**KING CITY PLANNING COMMISSION
MEETING**

- a. **PUBLIC HEARING: CASE NUMBER 19-02 (PONDEROSA PINES).**
- b. **ADU OVERVIEW AND DISCUSSION**

TO: King City Planning Commission
FROM: Keith Liden, Planning Consultant
SUBJECT: Castle Oaks South Subdivision (Case No. 19-02)
Staff Report
DATE: January 21, 2020

Figure 1 - Parcel Map

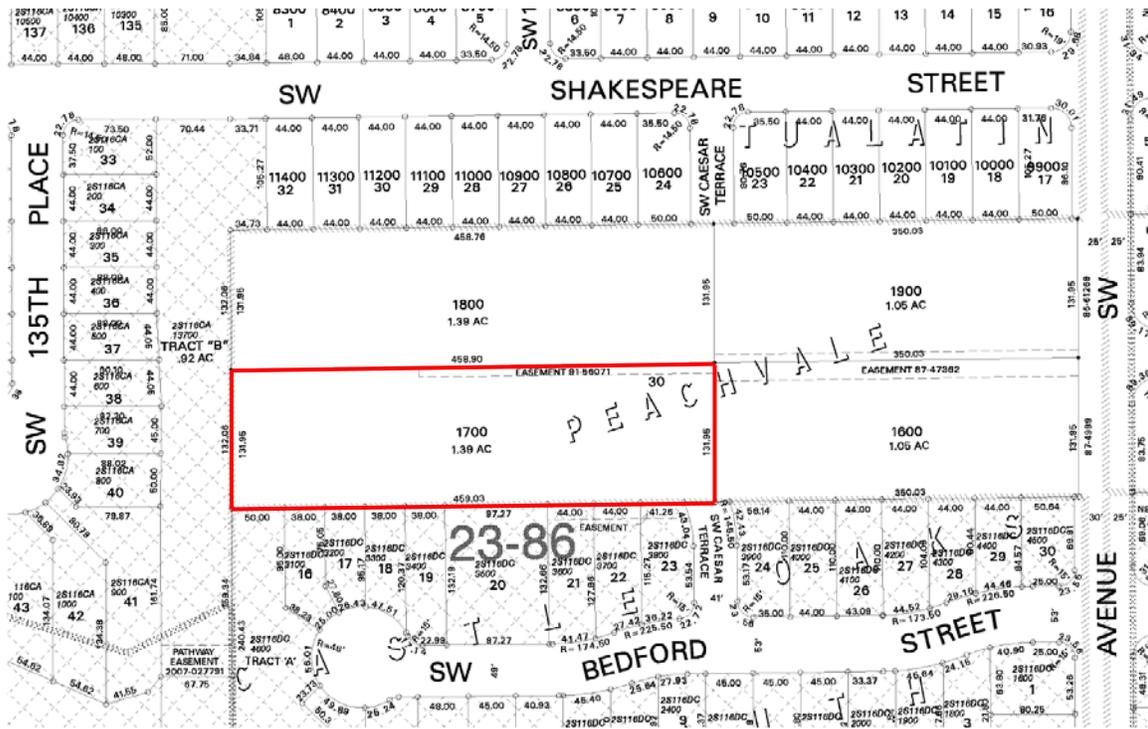
The application does not clearly describe how the existing access easement serving Tax Lots 1600, 1700, 1800, and 1900 (see Figure 1) will be dealt with. It is a private easement, and in its current condition and width of approximately 10 feet, it is not suitable or safe for public use. The plan for the final subdivision plat must include a method for prohibiting general public use of this easement.

SHEET NUMBER
C260

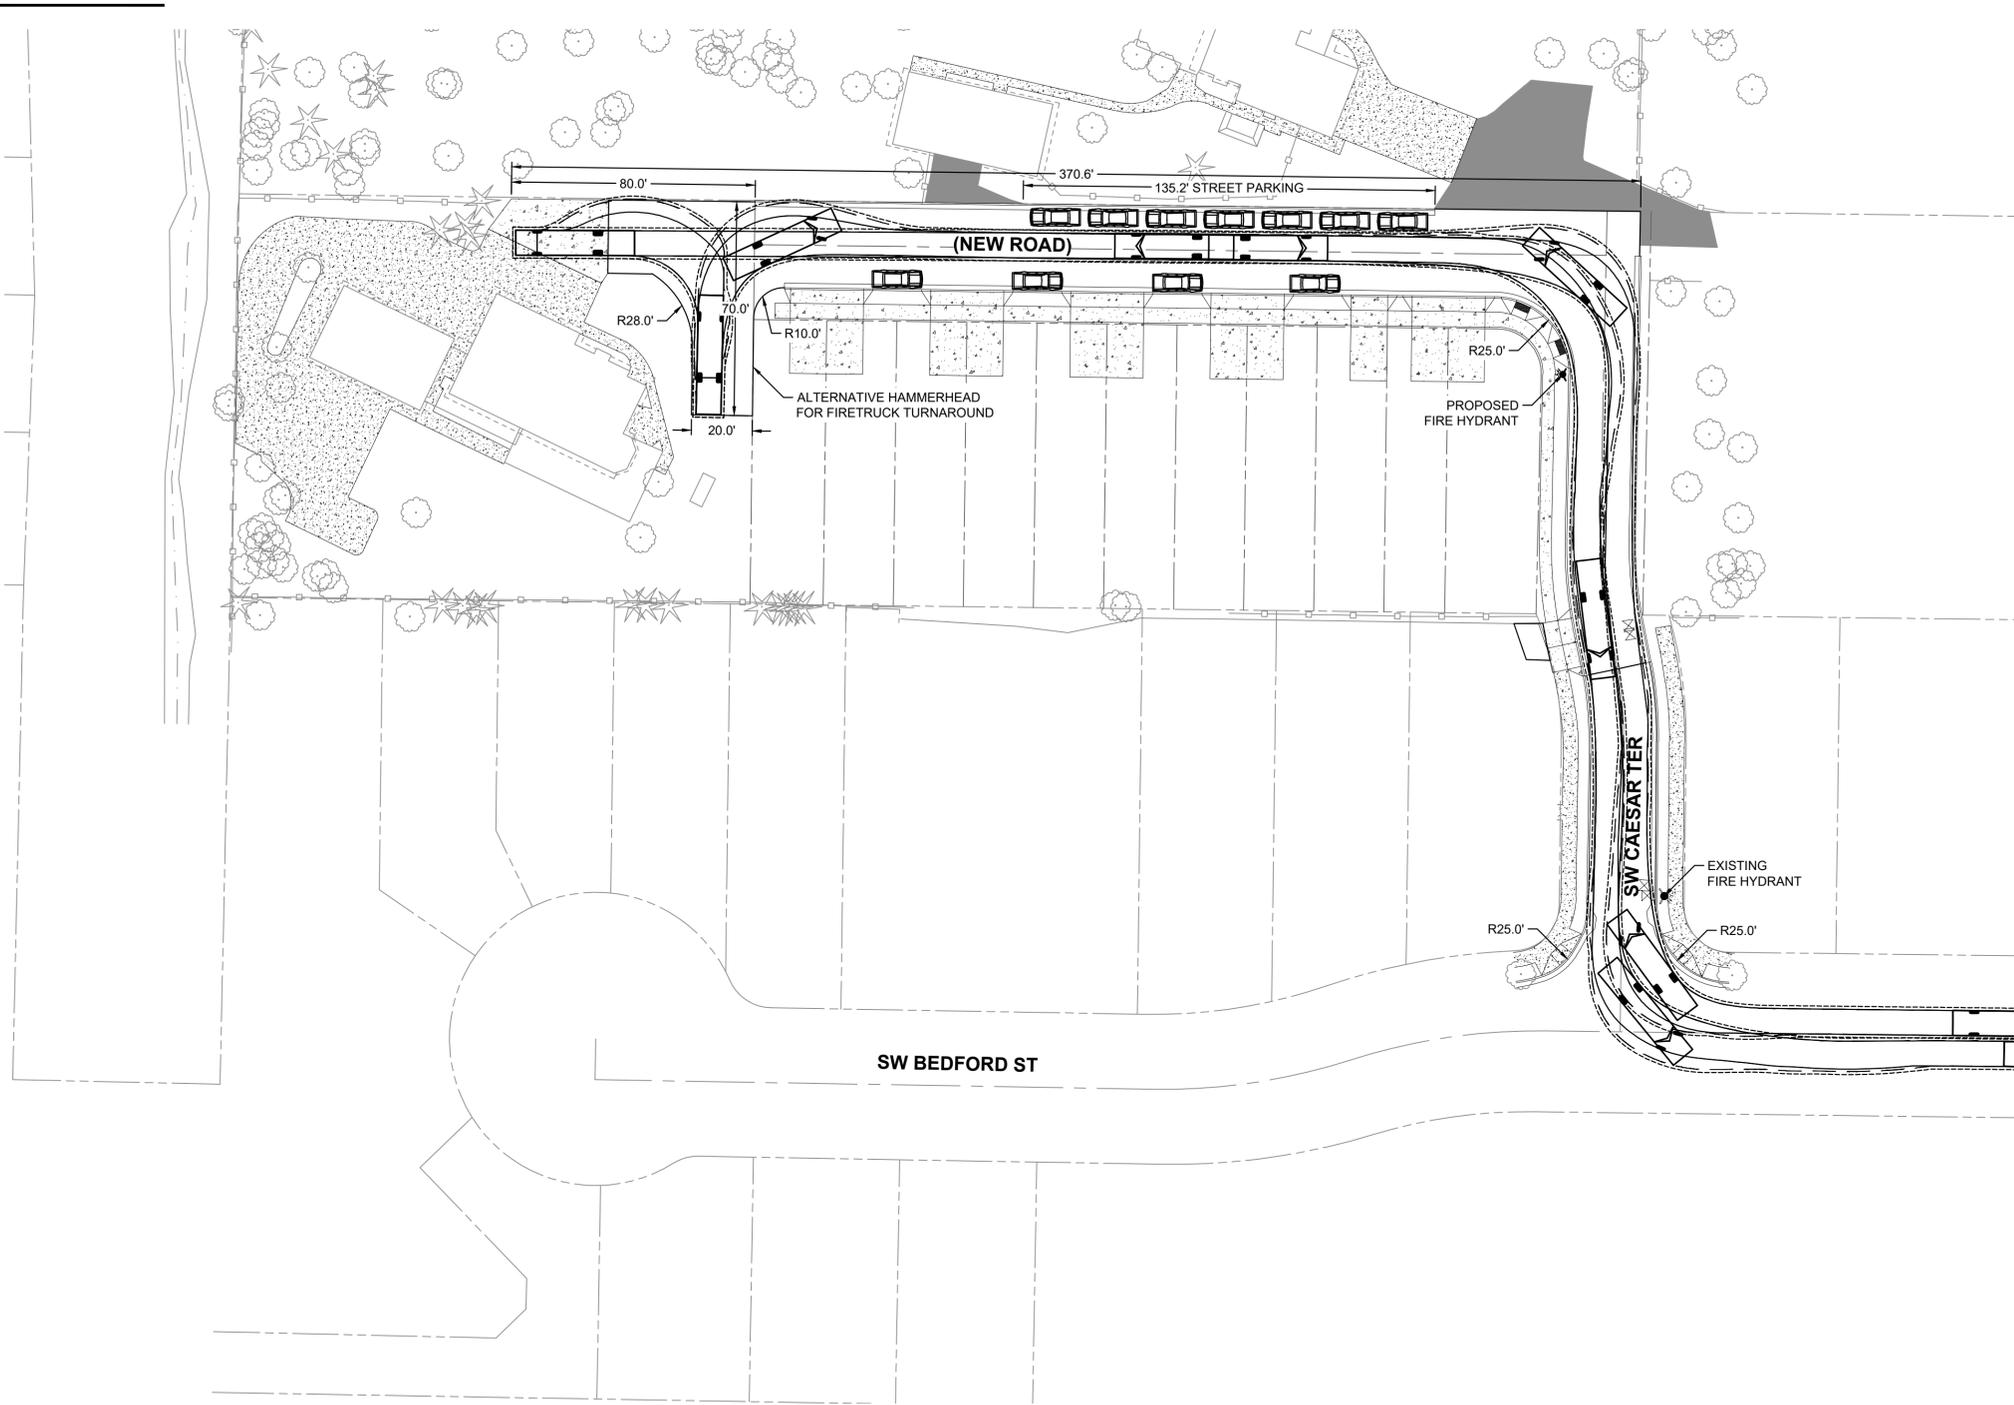
Tualatin Valley Fire and Rescue (TVFR) submitted comments regarding the application (Exhibit B). TVFR lists a number of requirements that will be expected as plans are finalized and the subdivision is developed. TVFR specifically does not approve of the proposed on-street parking shown on the fire access plan (Sheet C260).

Previous residential developments have experienced on-street parking issues where there has been a combination of narrower streets (e.g., 22-28 feet), single car garages, and no alley-loaded lots. This has occasionally led to problems with illegal parking and restricted emergency access. The proposed 22- and 28-foot wide streets will provide limited on-street parking opportunities through the development. The parking plan shown on Sheet C260 shows 11 on-street spaces, but it is not approved by TVFR, as noted in this agency's comments (Exhibit B). A revised on-street parking plan is required as a condition of approval.

2. 26-32 feet road width – **parking is allowed on one side. Plans provided show parking on both sides. Only parking on one side is allowed.**
 3. Greater than 32 feet road width – parking is not restricted

8. **FIRE APPARATUS ACCESS ROADS WITH FIRE HYDRANTS:** Where a fire hydrant is located on a fire apparatus access road, the minimum road width shall be 26 feet and shall extend 20 feet before and after the point of the hydrant. (OFC D103.1) **26" is not provided at hydrant on plans submitted. Relocate hydrant to meet this requirement.**

10. **TURNING RADIUS:** The inside turning radius and outside turning radius shall not be less than 28 feet and 48 feet respectively, measured from the same center point. (OFC 503.2.4 & D103.3) **Radius shown on plans provided do not show that minimum radius is provided.**

- b. An on-street parking plan that satisfies access requirements of TVFR and Pride Disposal.
 - c. Street improvements consistent with city standards.
